Subject: CHECK ENGINE LIGHT ON WIT DTCS P0012, P0011, AND POSSIBLY P0010	Service Alert No.: SA-033/25
	Last Issued : 06/20/2025

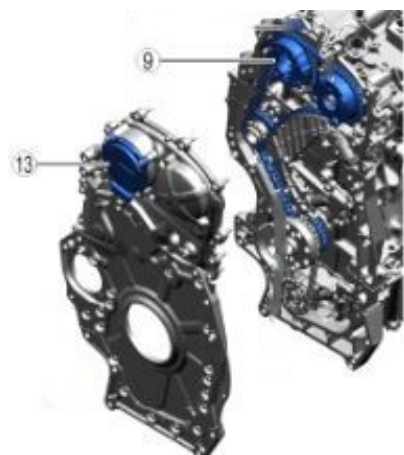
Some vehicles may experience a CHECK ENGINE light ON with DTC P0012, P0011, and possibly P0010. This may be caused by a malfunction in the intake EVVT motor that prevents it from accurately regulating the intake camshaft timing.

According to the WSM, replace the intake EVVT motor #13 with an updated EVVT motor.

NOTE: DO NOT replace the cam actuator #9.
